ADDRESS: 2517 Eastlake Ave E
Seattle, WA 98102

SDCI PROJECT NO: 3033787-EG

7.1 | OVERALL RENDERINGS 86

4.0 | EDG RESPONSE: ARCHITECTURAL CONCEPT

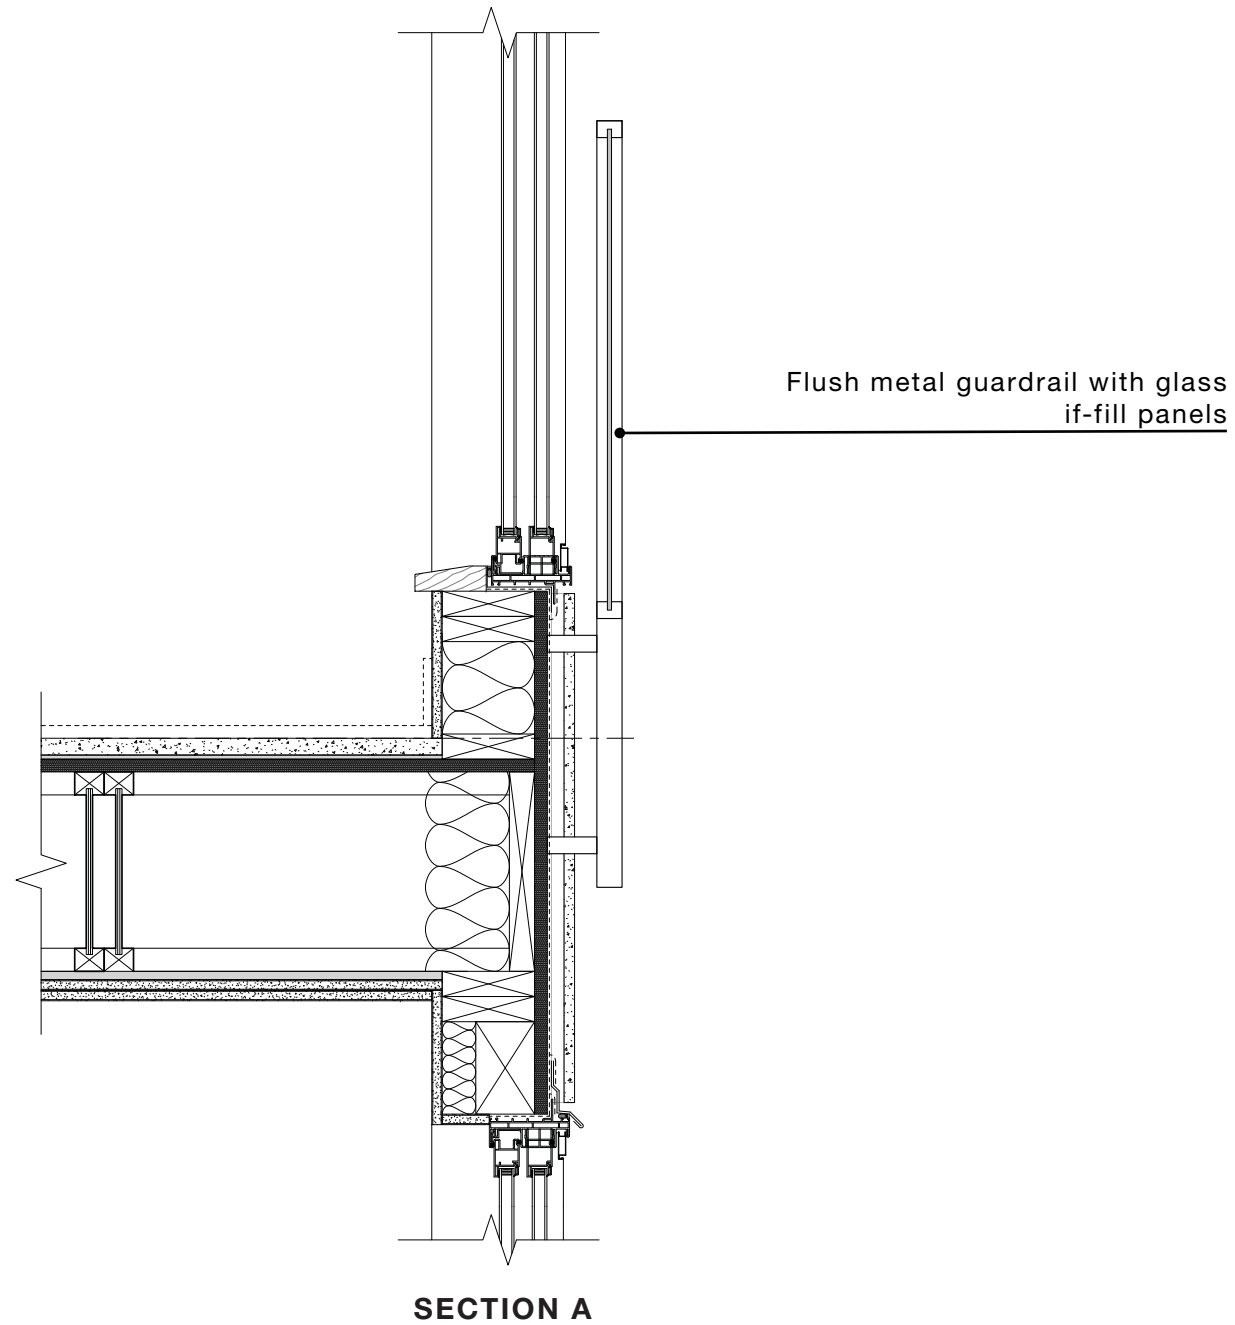
3c. The Board noted several unsuccessful nearby projects with similar compositional approaches and agreed that a simple composition of a few high-quality materials would likely be more effective. (DC2, CS3)

+ Flush metal balconies with glass in-fill add to the facade composition as described on the previous page.

EDG | 05.29.2019

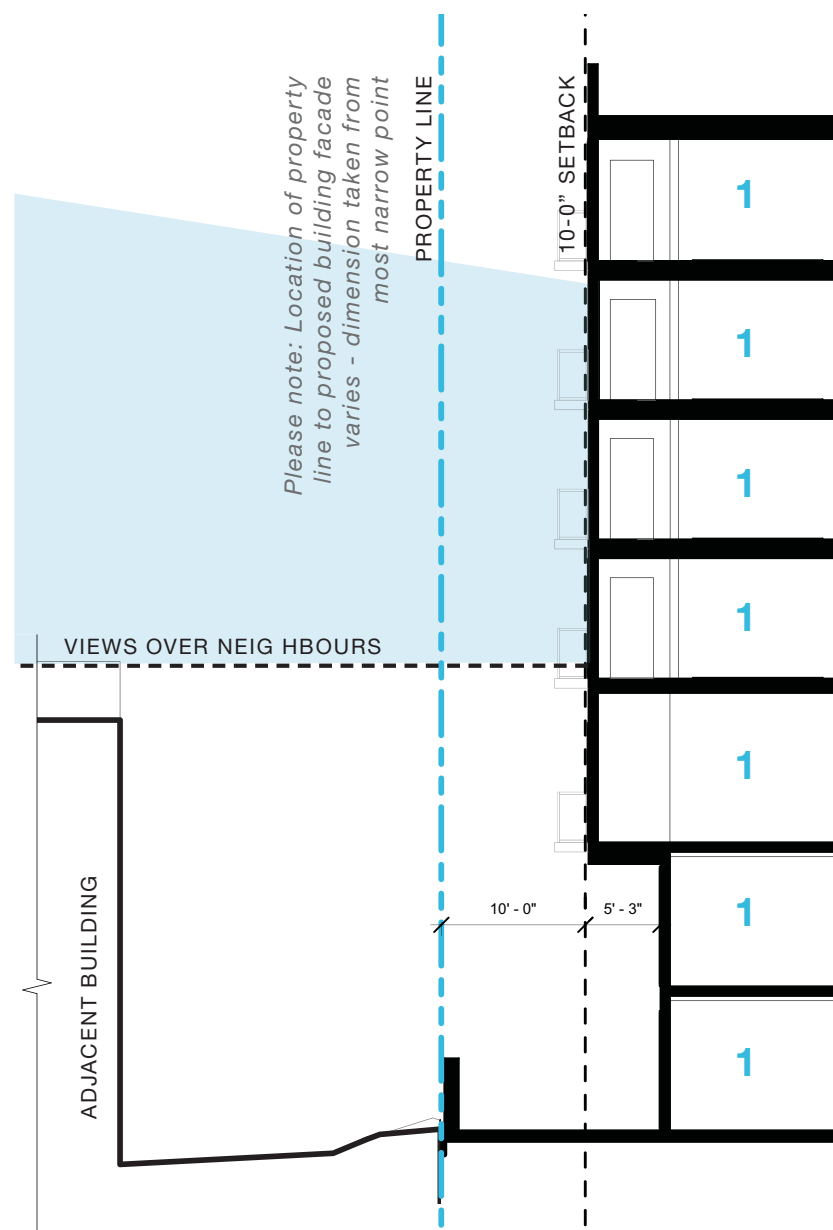
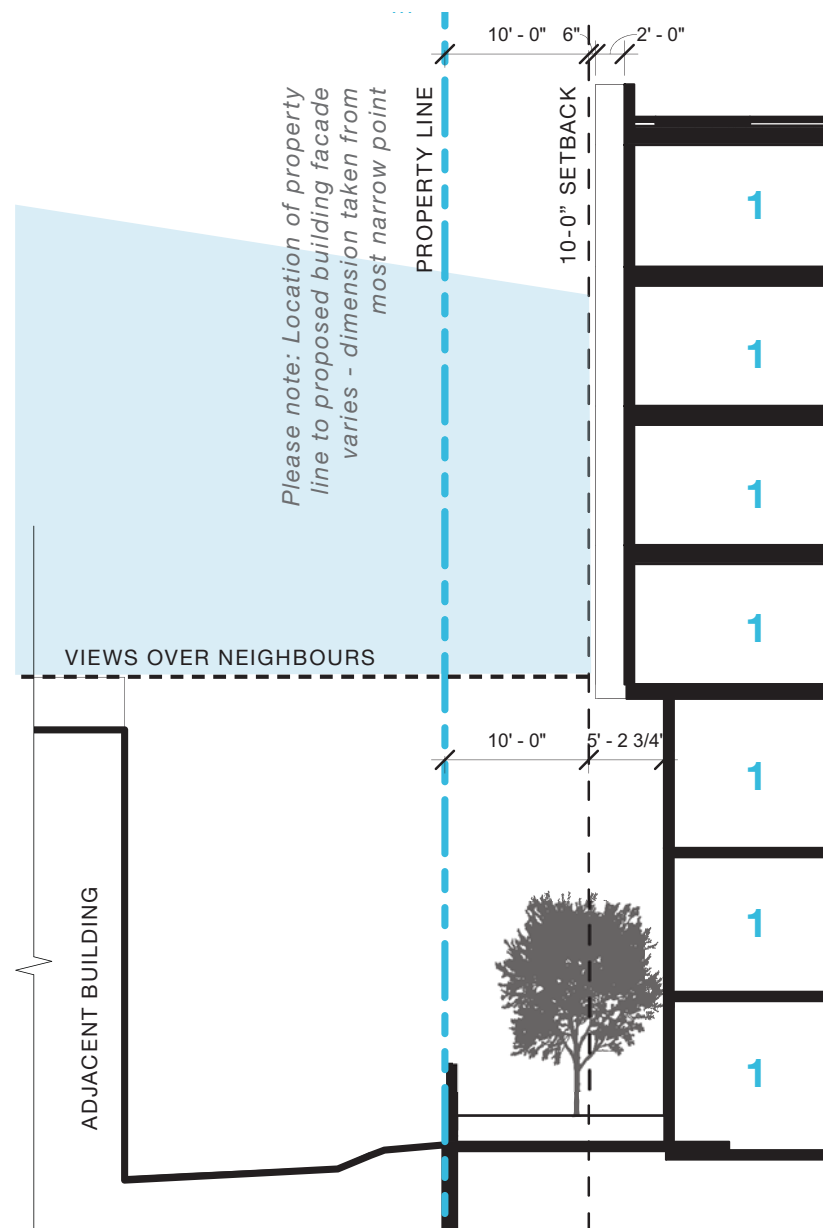
DESIGN REVIEW BOARD DIRECTION:
 2a. Echoing public comment, the Board identified this edge and zone transition as a critical project element and agreed that the combination of topography and less-intensive zoning presented a unique challenge that would require careful composition. (CS2-D, CS2-D)

+ In addition to the comparison plans on p. 59, a comparison of walls sections between the EDG and Recommendation proposal shows a greater degree of setback above and below the roof line of the neighbors. These setbacks exceed the zoning requirement.

MUP | 08.05.2019

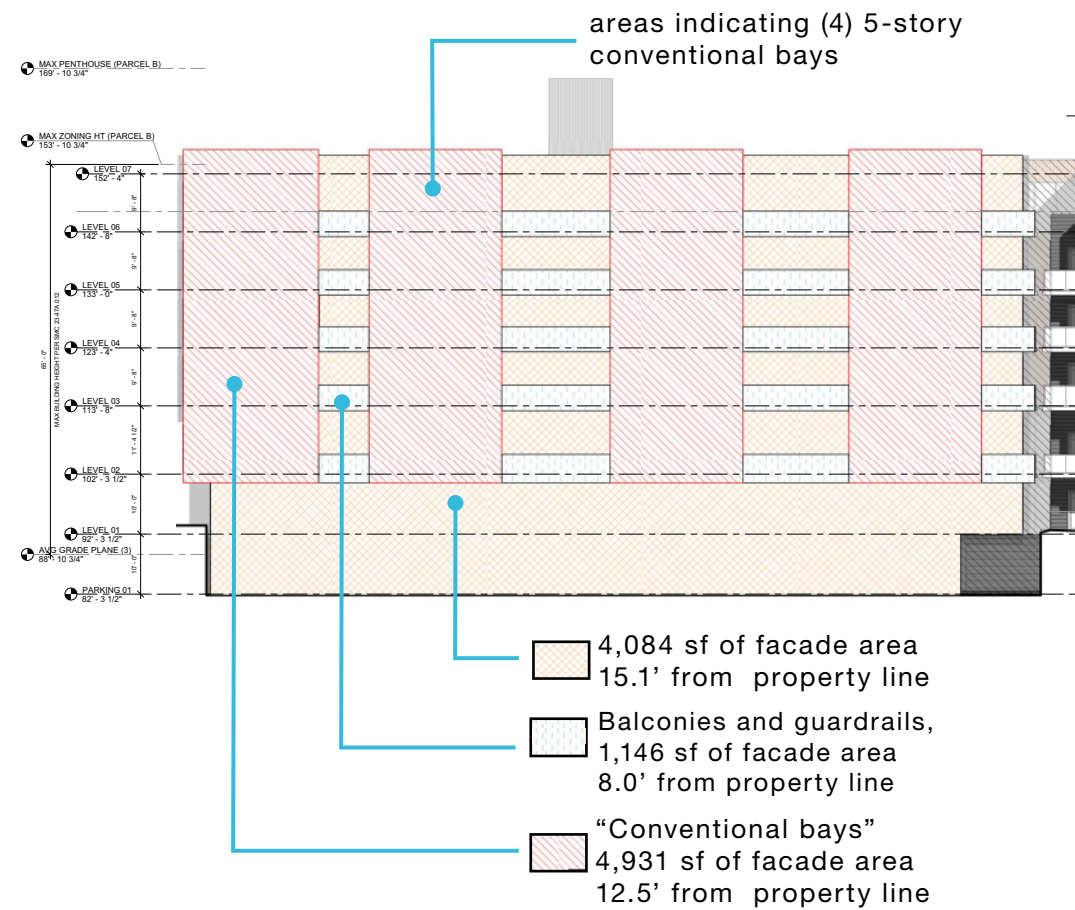
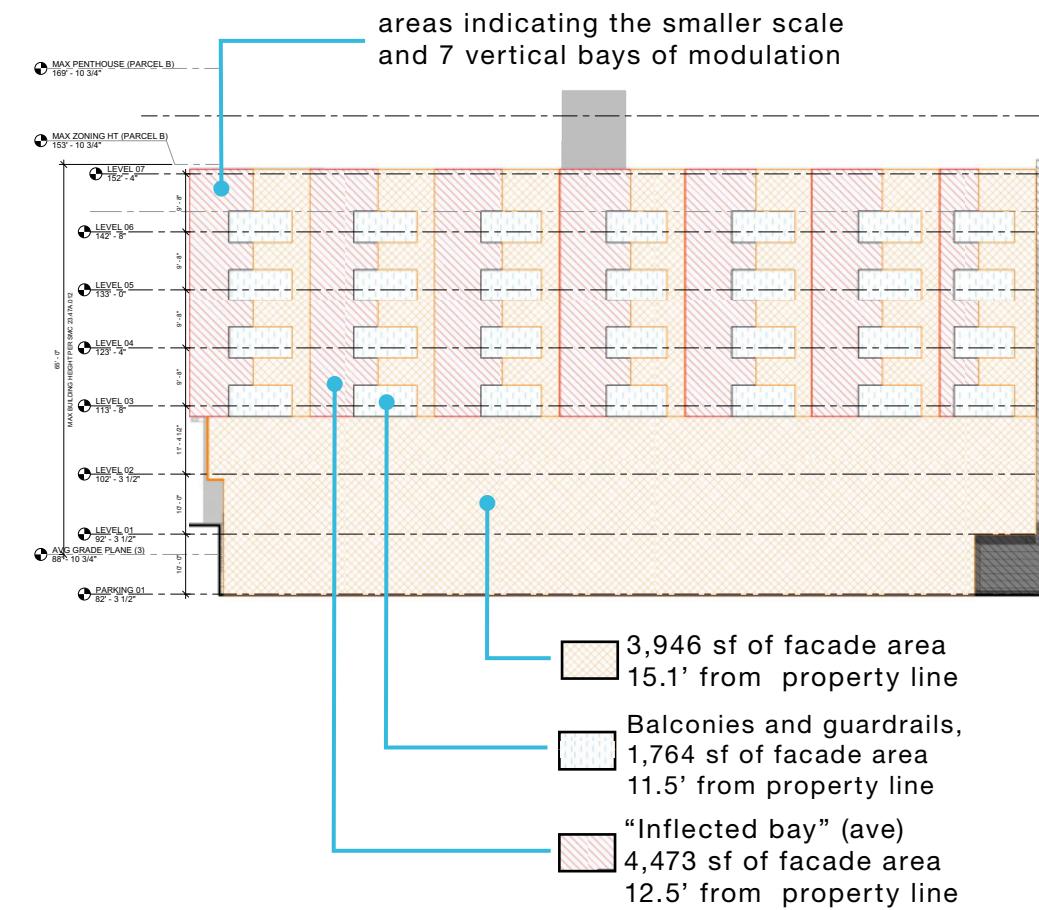
DESIGN REVIEW BOARD DIRECTION:
 2a. Echoing public comment, the Board identified this edge and zone transition as a critical project element and agreed that the combination of topography and less-intensive zoning presented a unique challenge that would require careful composition. (CS2-D, CS2-D)

- The proposed average facade area distance from the property line is greater than the EDG version (13.3')
- The 13.3' average facade distance exceeds the required 10'-0" setback per zoning.
- The 7, 4-story tall "inflected bays" provide more modulation at a smaller scale than the 5-story tall vertical "conventional bays"
- No portion of the facade or balconies are within the setback, the EDG / MUP version proposed balconies 8.0' from the property line
- The balconies of the proposed are smaller in depth than the EDG / MUP balconies
- Additional story of 15.2' of setback below the roofline of the neighbors

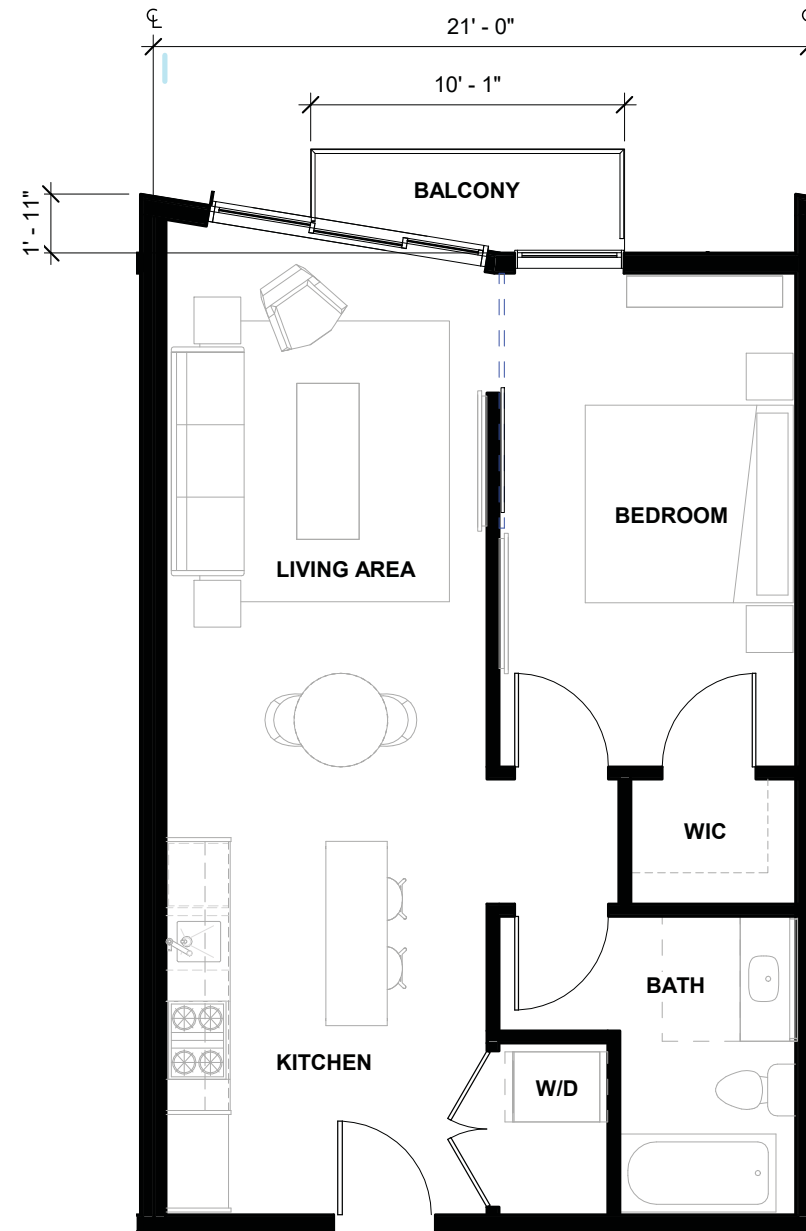
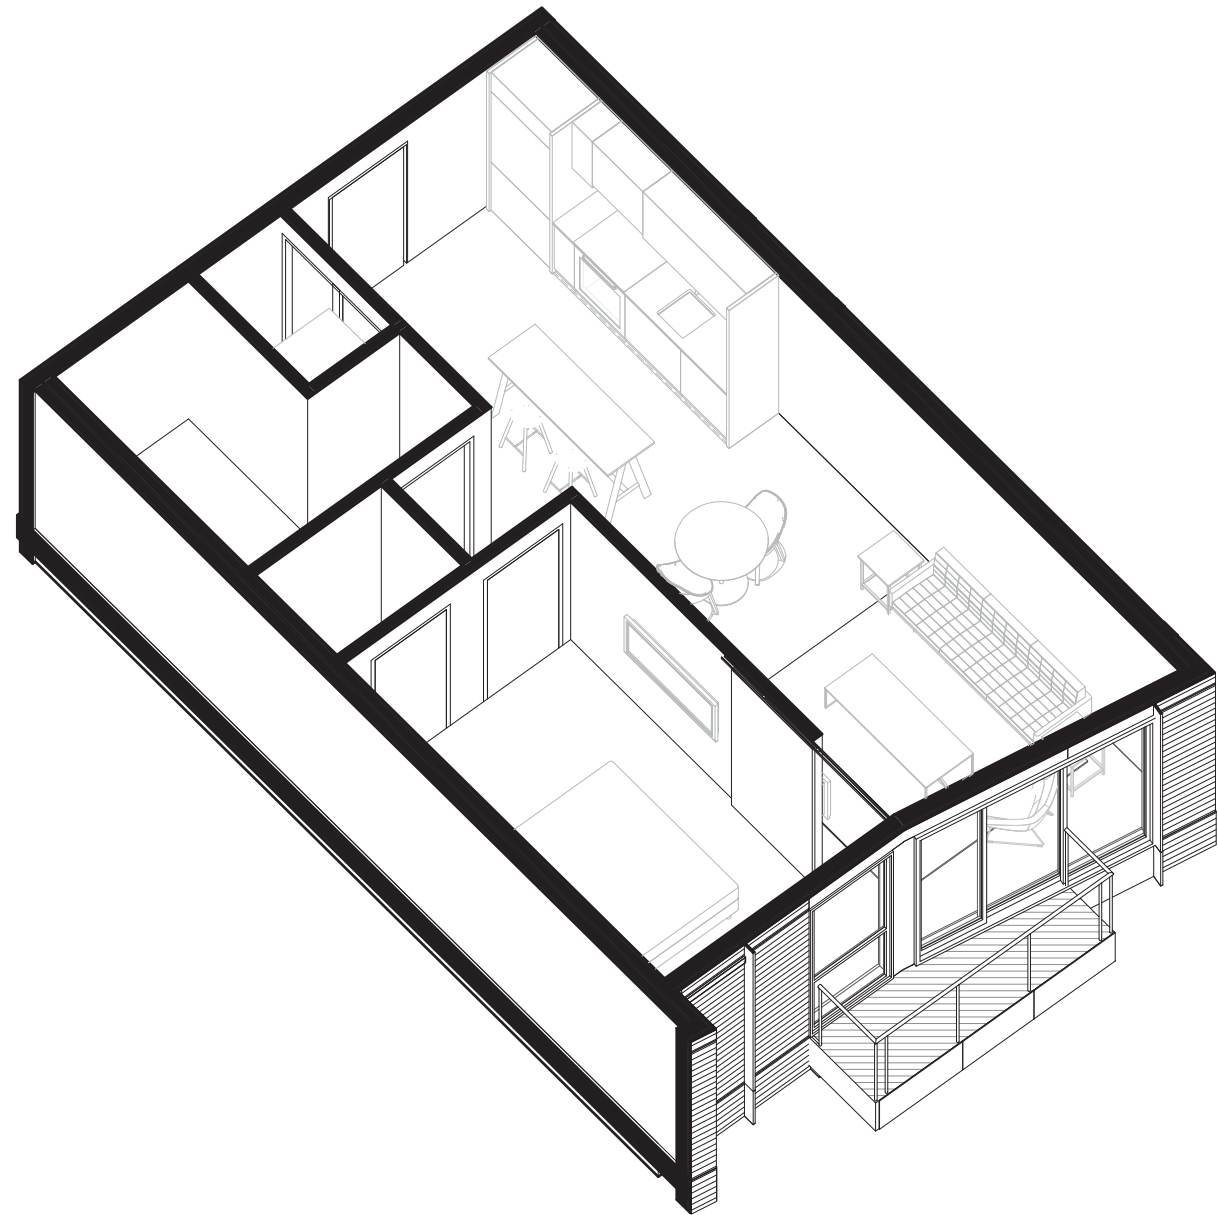
DESIGN REVIEW BOARD DIRECTION:
 2b. The Board supported the modulation of the project where it abuts Parcel (B) and agreed that further modulation and development would be required along Parcel (C) to provide the scale mitigation required at this zone transition. (CS2, CS3)

1a. The Board supported Option C and agreed that the idea of smaller forms combined in a larger whole could be an effective strategy for breaking down the scale of this large project. (CS2-D)

+ To the left is a typical unit of parcel B showing the inflected bay proposed to provide scale mitigation and facade articulation.
